Record of Decision
Carroll Town Landfill Site
Town of Carroll, Chautauqua County, New York
Site Number 9-07-017

March 2009

DECLARATION STATEMENT - RECORD OF DECISION

Carroll Town Landfill Inactive Hazardous Waste Disposal Site Town of Carroll, Chautauqua County, New York Site No. 9-07-017

PROPOSED
REMEDY
LAYOUT

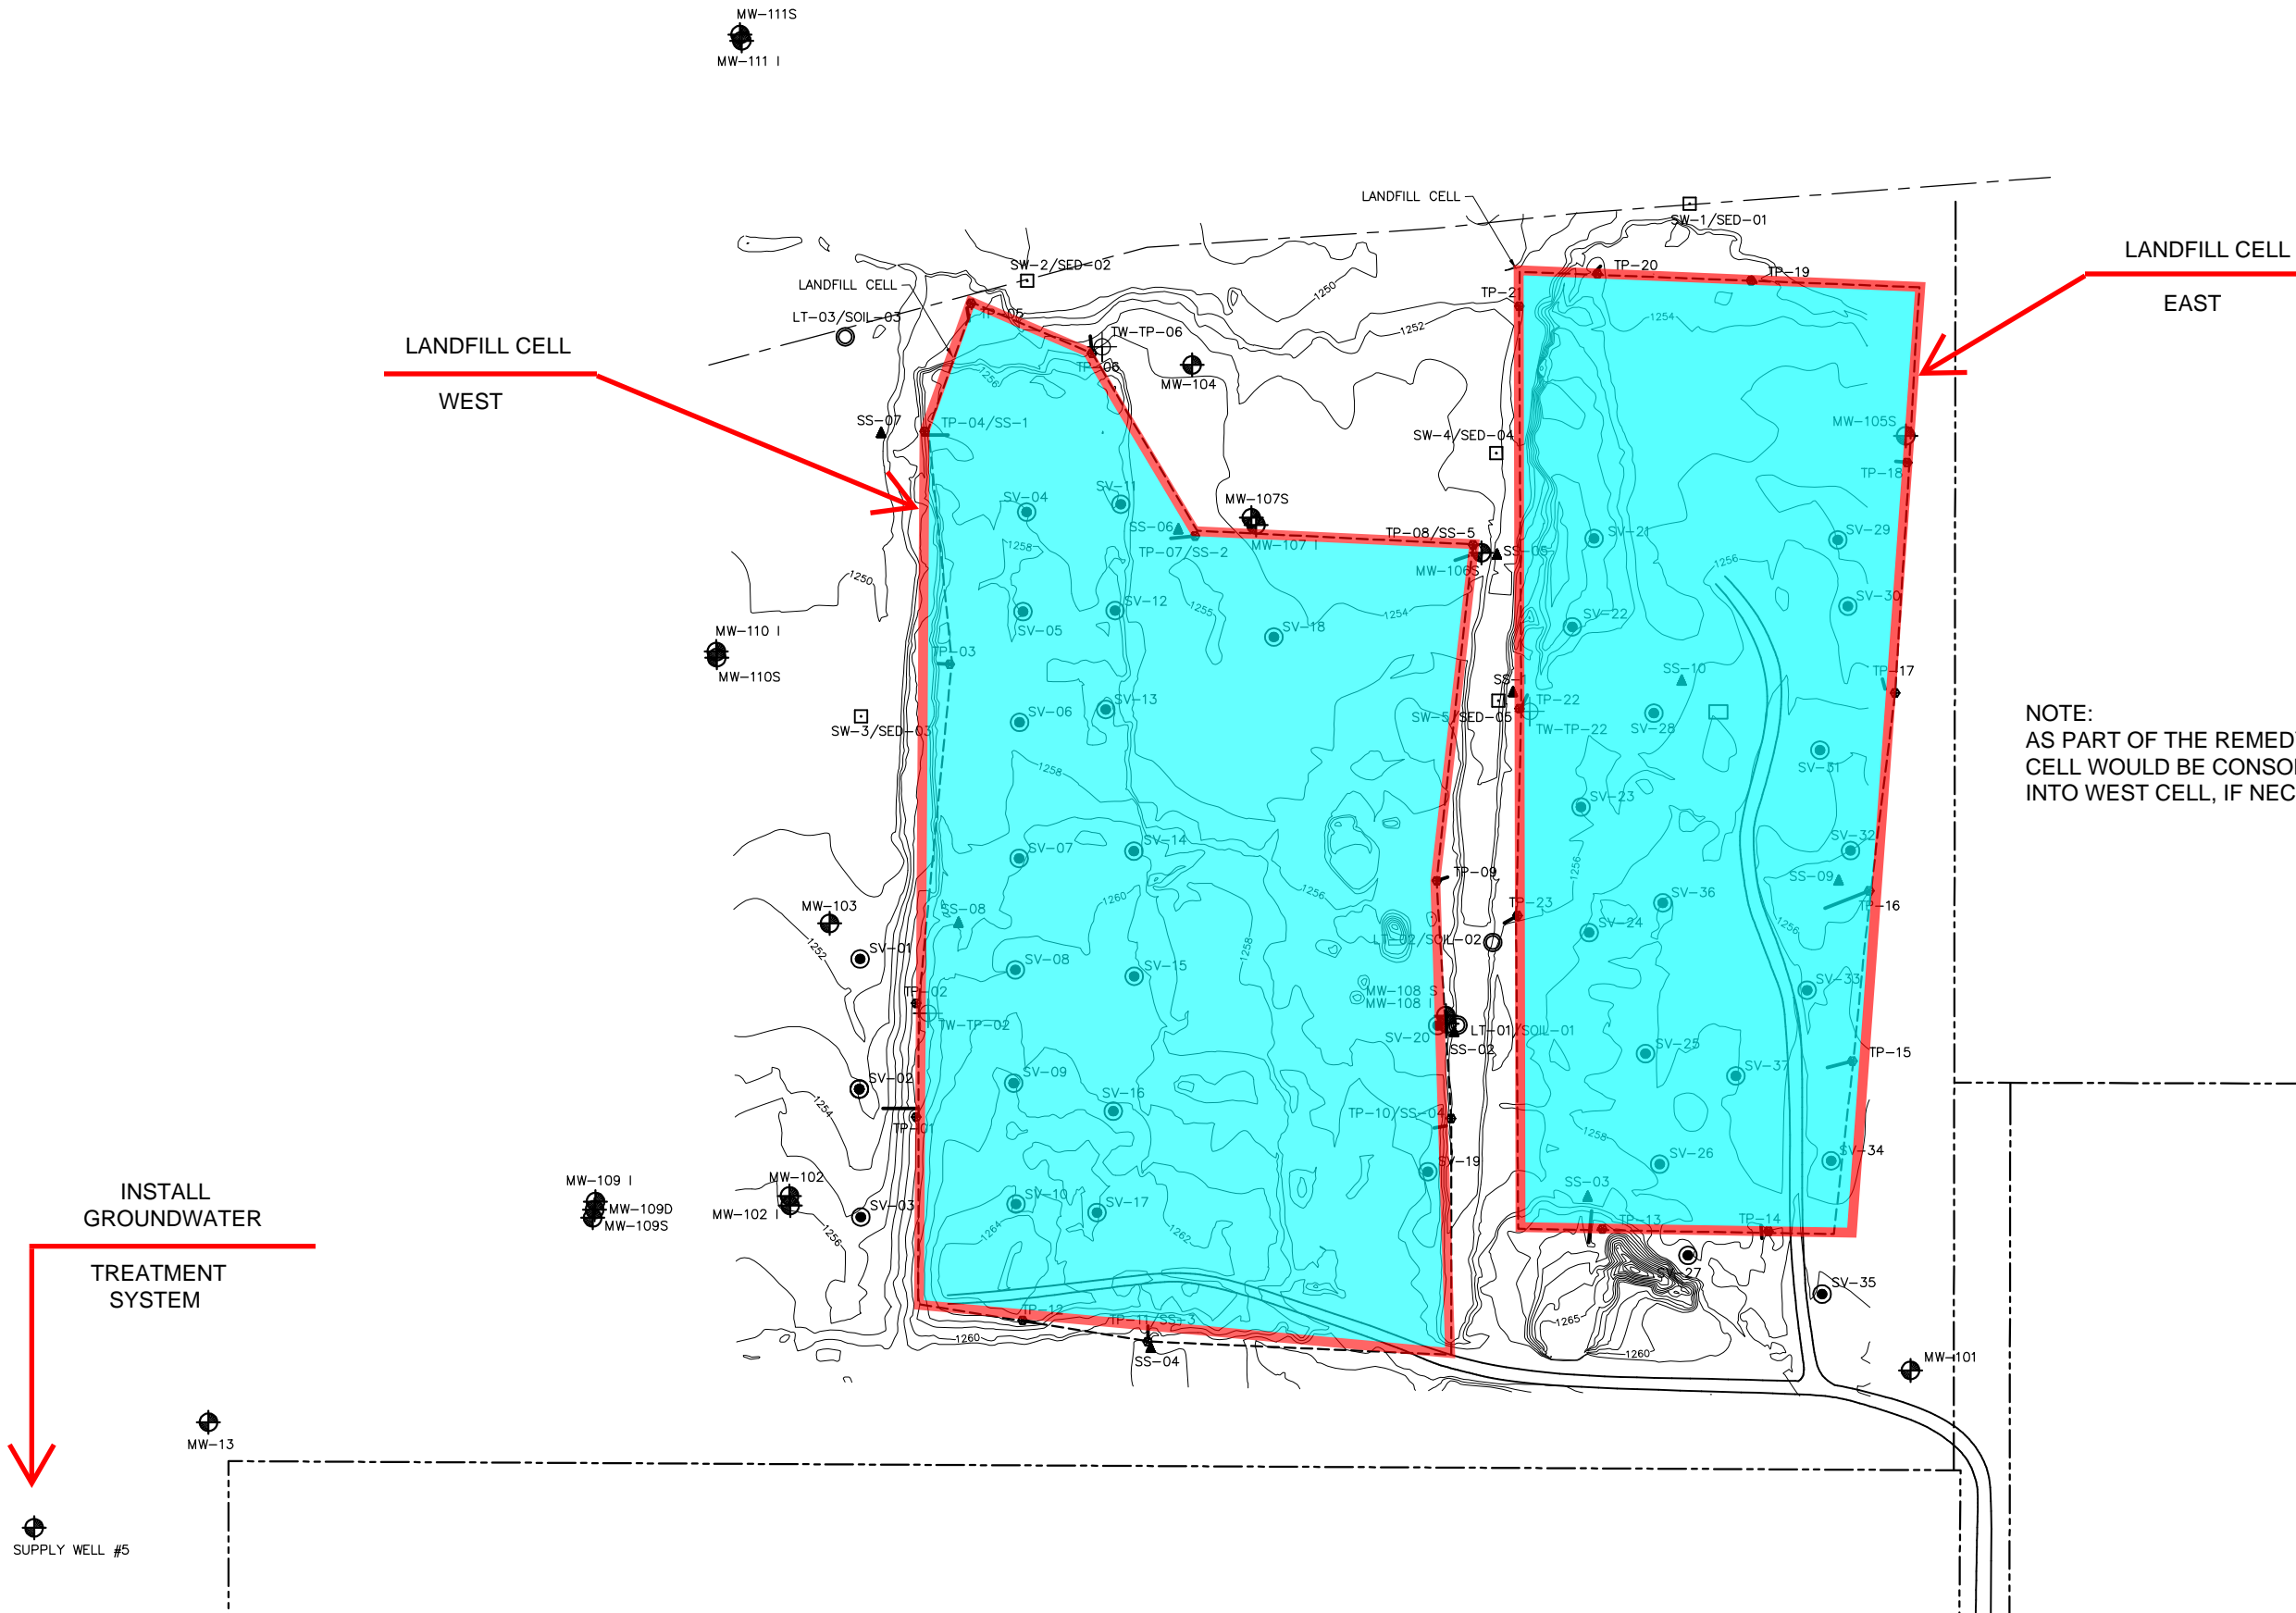
COMMENT 2: Why consolidate the waste into the west cell which is closer to public supply well PW-5? Why not consolidate the west cell into the east cell?

COMMENT 3: What are the benefits of consolidation? Why does the landfill need a cover and what are the advantages of the cover? We want to let you know that about fifteen property owners who live around the landfill will be against consolidation of the landfill.

RESPONSE 2: Consolidation of the east cell into the west cell is preferable because the east cell is smaller in size compared to the west cell and the groundwater samples from two of the monitoring wells installed on the west cell showed high concentrations of volatile organic compounds. Disturbance of the west cell could cause contaminants to migrate from the landfill. Additionally, the waste is found to be deeper in the west cell compared to the east cell. Therefore, less waste will need to be excavated from the east cell compared to the west cell for consolidation.

RESPONSE 3: Please refer to Response 1. Landfill consolidation would minimize the footprint of the landfill and therefore, minimize the amount of soil cover to be placed on the landfill and reduce the amount of water infiltrating into the landfill via rainfall or snowmelt. Also, after consolidation, the area currently occupied by the east cell would be available for unrestricted future use. A soil cover will be placed on the landfill with or without consolidation to eliminate direct contact with landfill waste and promote surface water runoff. The soil cover will minimize the amount of water that infiltrates into the landfill and hence, reduce the leachate originating from the landfill.
